Fig. 2.—Typical Cross-Section of North Approach.

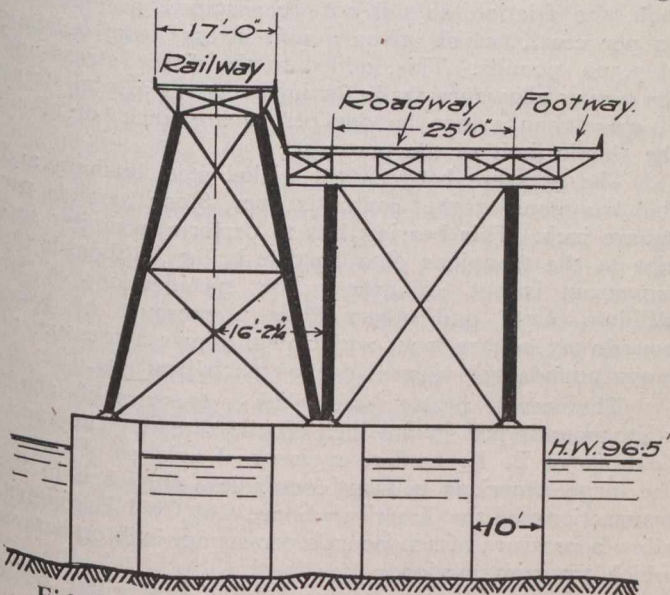
Two designs have been submitted for the north highway approach. One of these consists of the mushroom system, or flat slab construction; the other consists of plate girder spans on concrete columns.

The alternative design submitted for the north highway approach consists of a flat, reinforced concrete, continuous slab on reinforced concrete columns on a pile foundation.

We do not consider that this is a good type of construction for this location. The strength of the structure depends upon a total absence of settlement of the supports, which it is practically impossible to get in this location with the details shown. Some of the supporting piles have a load of about 45 tons, or about 20 tons per pile overload.
